Smarter journeys, together. Wakatipu Active Travel

COMMUNITY ENGAGEMENT SUMMARY
MARCH 2021

Progressing improvements to Wakatipu Trails

A3 JOE O'CONNELL DRIVE TO FRANKTON BEACHFRONT

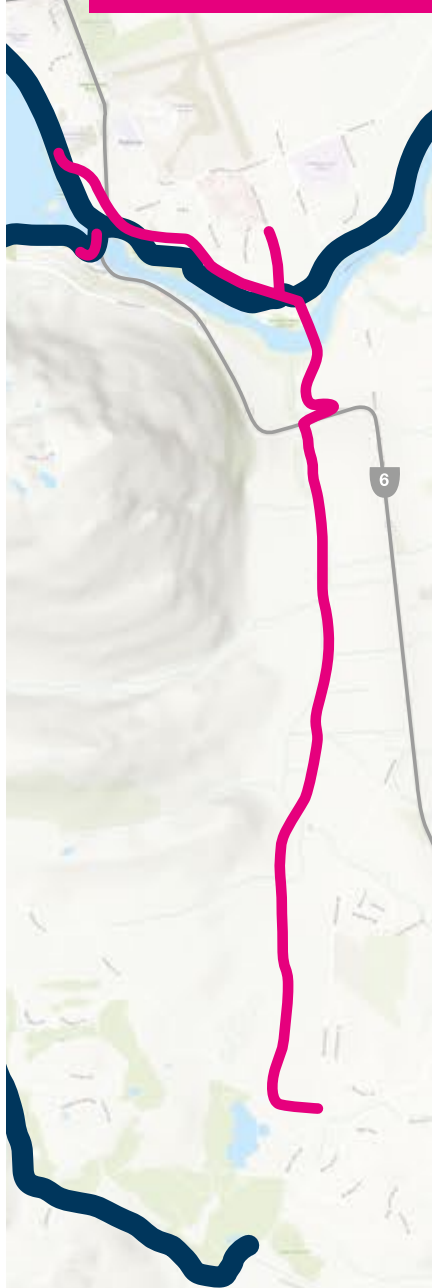
There should be a more direct route from Five Mile and Joe O'Connell Drive to the Frankton Beach/ Marina/ Frankton Bus Hub.

There should be a direct connection between SH6 and the lakefront for cyclists.

Queries regarding surfacing of the trails.

Concerns raised that the speed of cyclists may cause conflict with walkers/runners.

More bike parks at various points in the Five Mile Shopping Centre.

A temporary pathway is proposed adjacent to SH6 which connects directly from Joe O'Connell Drive to the roundabout. The route then connects via the existing crossing to Gray Street or the signalised pedestrian crossing adjacent to the Frankton Bus hub. The future BP roundabout project will address a more permanent solution to provide a more direct connection to the Marina as well. This project also includes a new pedestrian accessway adjacent to the Frankton camping ground.

Two routes between Yewlett Crescent and the Lakefront have been proposed to provide new safer and more attractive routes for pedestrians and cyclists. Pedestrians are provided a new footpath along Stewart Street and a new accessway via the camping ground (including stairs). The alternate route for cyclists is along Yewlett Crescent, Lake Avenue and Frankton Beach Access. This route has been chosen for its reduced gradient.

Generally, the pathways will be sealed. For unsealed sections, surfacing will enhance the experience for all users.

Consideration will be made for the various pathway users to enhance safety for everyone.

Although toilets and other amenities do not form part of this project the potential need and opportunity for such will be raised with QLDC.

A7 JACKS POINT TO FRANKTON TRACK

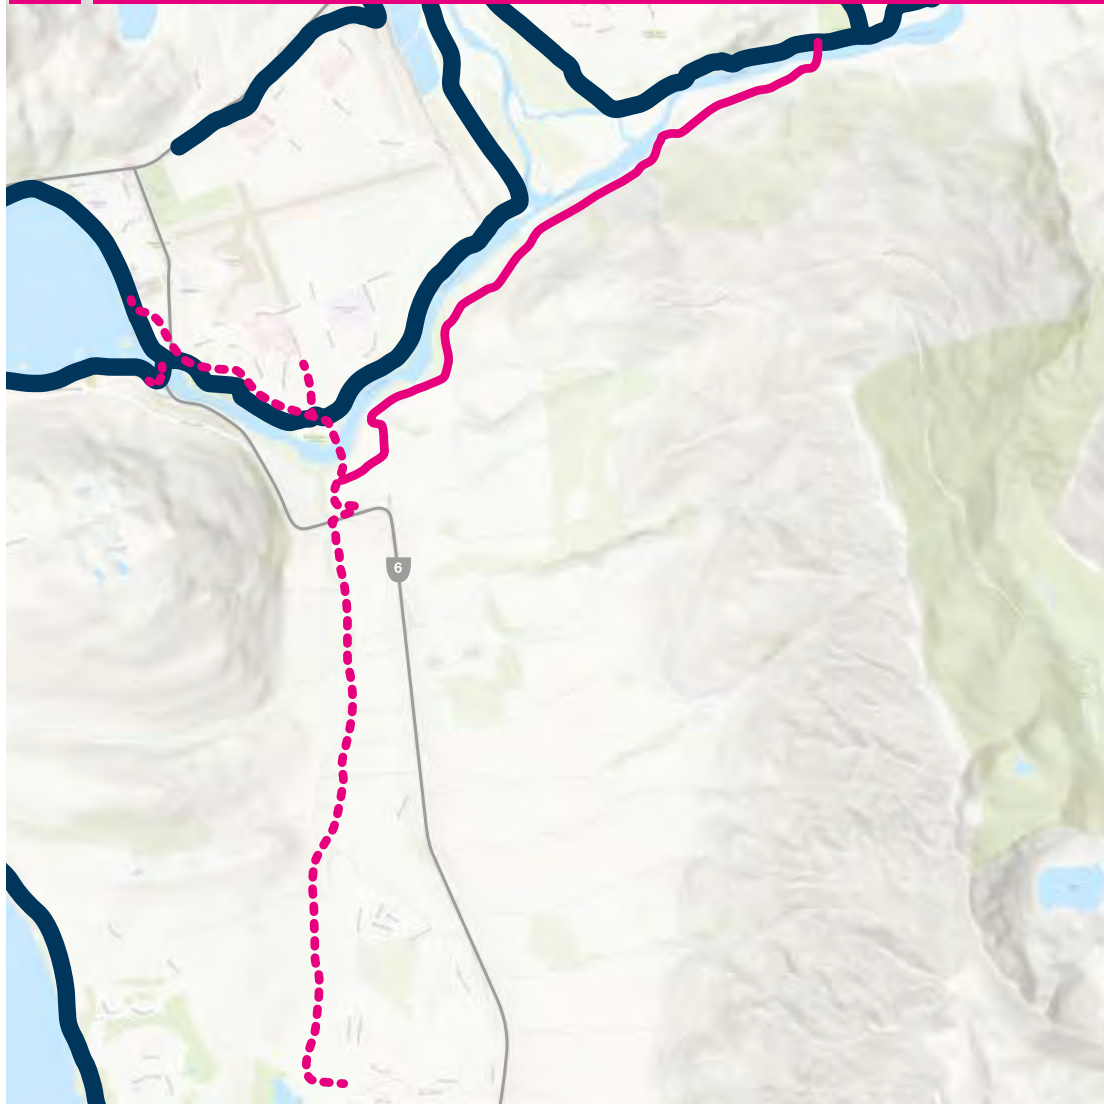
The trail from Hanley's Farm to the Frankton bridge is ideal, a sidewalk would be useful.

Suggestion for a connection from Hanley's Farm to the Jacks Point trail, which is the trail that links Jacks Point to Kelvin Heights via the lake edge.

Support for the new direct connection from Hanley's Farm and Jacks Point to Frankton. These submissions also highlight the need for a prioritized corridor for cyclists to address safety issues associated with riding along SH6.

Several submissions suggest lighting is not necessary along this route due to the likely recreational nature of the trail and would have negative impacts including light pollution and impacts on wildlife.

Requests for a sealed path to enable a wider range of transport modes to use the trail comfortably including e-scooters.

The steep hill at the Kawarau Bridge needs to be dealt with. It is impossible to bike up the hill and definitely not possible with a bike trailer that holds a child.

Support for the bridge over Kawarau west of Boyd Road with a request for further detail of the location.

Suggestion for this route to be a dedicated path through the subdivisions - ideally to the west of the subdivisions along the base on Peninsula Hill. A path that provides a direct link between Frankton and Jacks/Hanleys (can be in metalled formation) - but provides regular links into the streets of the subdivisions.

Footpaths along the road are being developed as part of the Hanley's Farm subdivision. A walking and cycling trail that provides a connection between Hanley's Farm and Frankton is being provided as part of this route.

This is beyond the current scope of works.

An underpass is proposed to remove the safety issues of crossing the SH6 and the bridge will connect pedestrians and cyclists directly to Frankton.

Lighting is being considered across all trails. The application of lighting may need to vary across the trails, as usage and Crime Prevention through Environmental Design considerations will be variable.

The pathway is proposed to be sealed.

The trail in this location will stay at a high level to bypass this steep climb. The trail then crosses SH6 via a new signalised crossing at Humphrey Street.

Location is still to be determined. Design investigations and landowner coordination are ongoing.

Noted. The new route will largely be a dedicated path along the utilities corridor easement and through upcoming planned subdivisions, except where the developments have already been approved.

A8 LAKE HAYES ESTATE TO FRANKTON

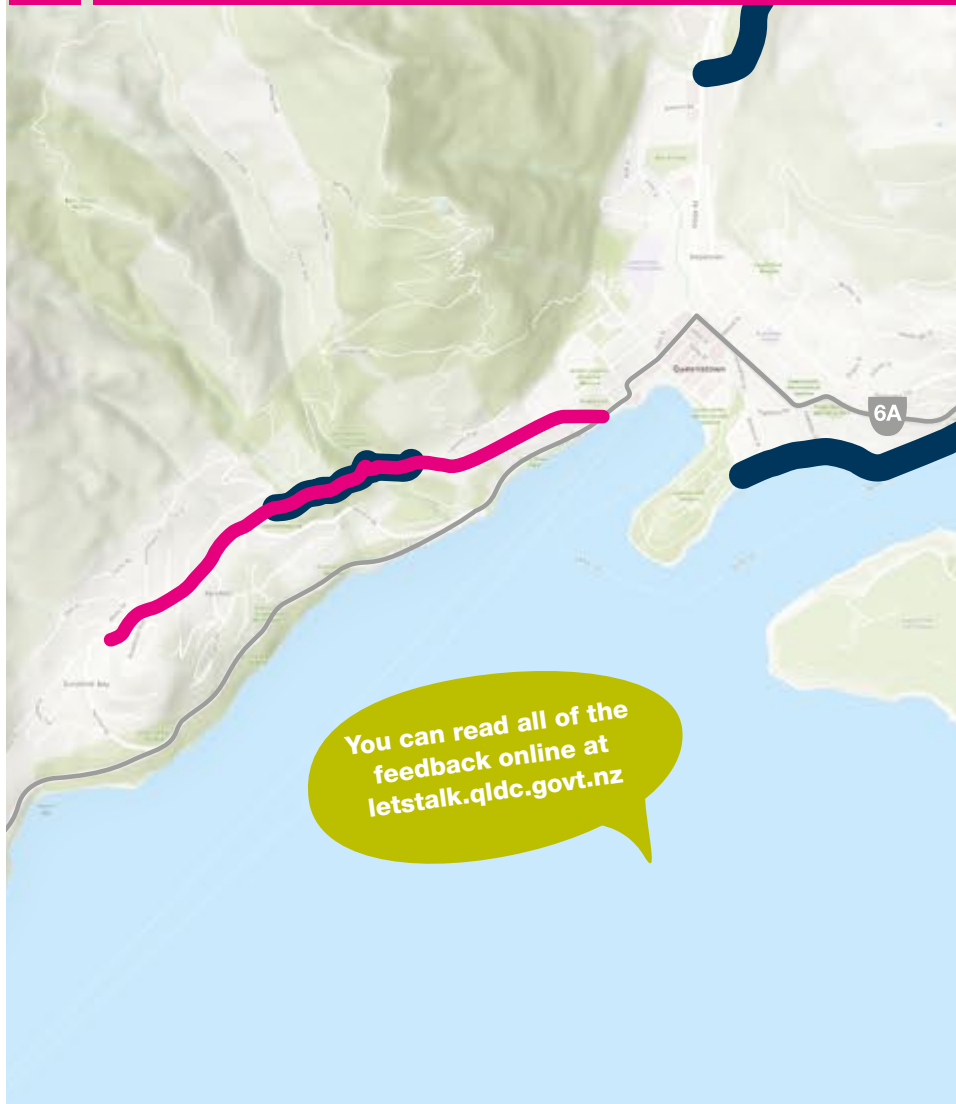
A quicker, more direct commuter route is wanted.

Safer crossing point(s) over SH6 are wanted.

Support for lighting along the route.

Consideration has been made for route options through this area at the business case phase.

This route does not go near SH6 and therefore this would need to be considered as part of other improvements.

Lighting is being considered across all trails. The application of lighting may need to vary across the trails, as usage and Crime Prevention through Environmental Design considerations will be variable.

B2 FERNHILL TO QUEENSTOWN

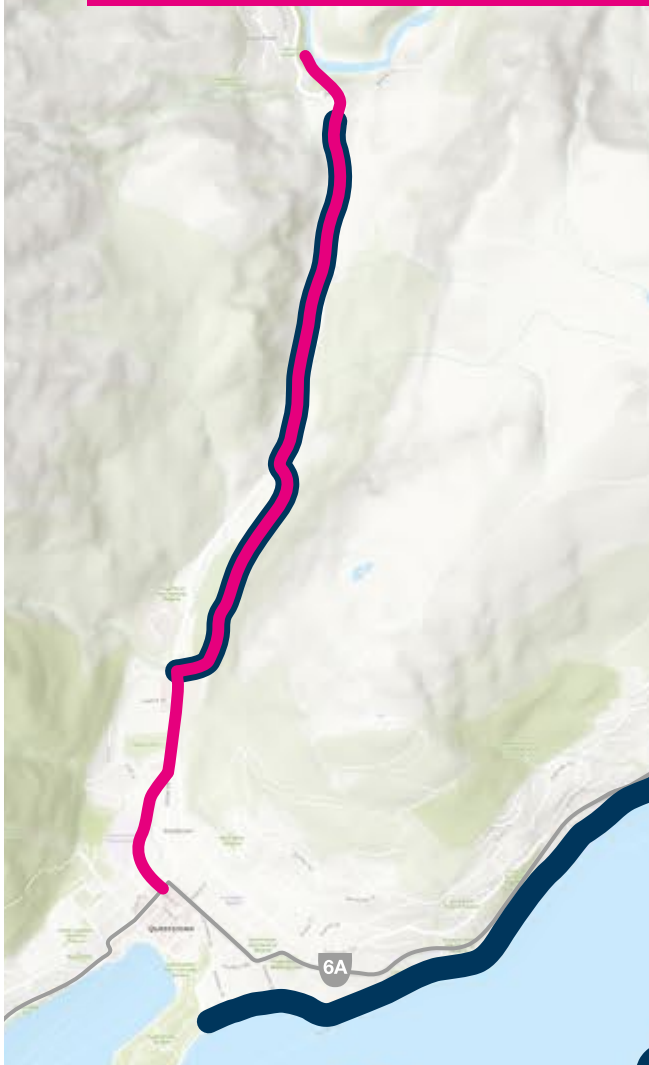
None of the respondents who live in the area want parking removed from Cameron Place.

Parking doesn't need to be removed from Fernhill Road between Lordens Place and Mackinnon Terrace, this is not heavily used by cycle commuter traffic.

Lighting in One Mile Reserve is supported.

There is already a suitable access onto the existing cycle route via the Fernhill Reserve car park and playground area that should be utilised rather than sending cyclists down Cameron Place.

We will look at a shared space alternative which will keep the existing carparking on Cameron Place.

We will reduce the length of the footpath widening for Fernhill which will retain some car parking. The footpath widening will now be between Watts Road and Greenstone Place.

We will investigate this as an option.

This is outside the scope of this project as the route was confirmed during the business case phase of the project.

ARTHURS POINT TO QUEENSTOWN IMPROVEMENTS

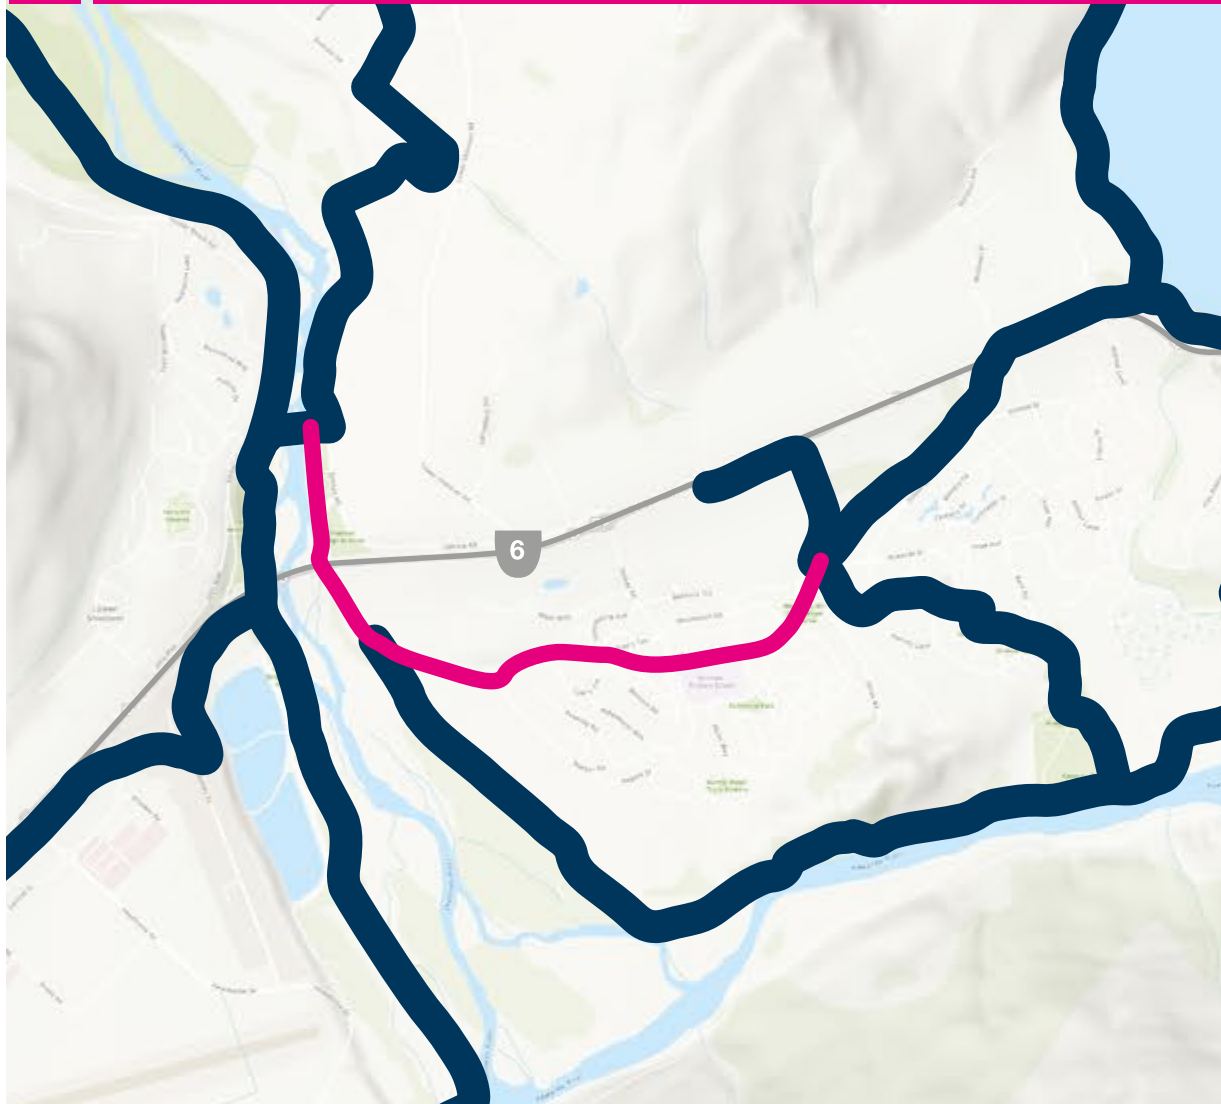
The improvements must be done at the same time as Arthurs Point Crossing.

Respondents preferred a direct on-road option to bypass Matakauri Park.

There was greater support for leaving the trail around Matakauri Park unsealed, but this would likely limit the use of the trail as a commuter route. Track surface would need to be sealed (asphalt not chip seal) to encourage uptake as a commuter route and to allow for different users (e-scooters/skateboards).

Most respondents were supportive of removal of car parking, but with some concerns raised regarding parking already being an issue for people in and near to town and the commercial premises.

There were safety concerns raised about crossing Gorge Road at Matakauri Park – needs to take account of longer bikes (e.g. cargo bikes) and greater volume of bikes.

We will look to coordinate with this project, which is in the final approval stages.

We are looking at shoulder widening on Gorge Road through this area to provide more road width for on-road cyclists.

We are not sealing around Matakauri Park Wetland. We are still assessing safe surfacing options for the rest of the route, this may be a combination of asphalt and chipseal.

We are investigating if parking on the opposite side of the road could be time limited so it can be used by businesses in the area.

We are currently investigating a signalised crossing that is user activated to allow people to cross safely. If the crossing point isn't signalised we will attempt to maximise any pedestrian refuge space as much as possible.
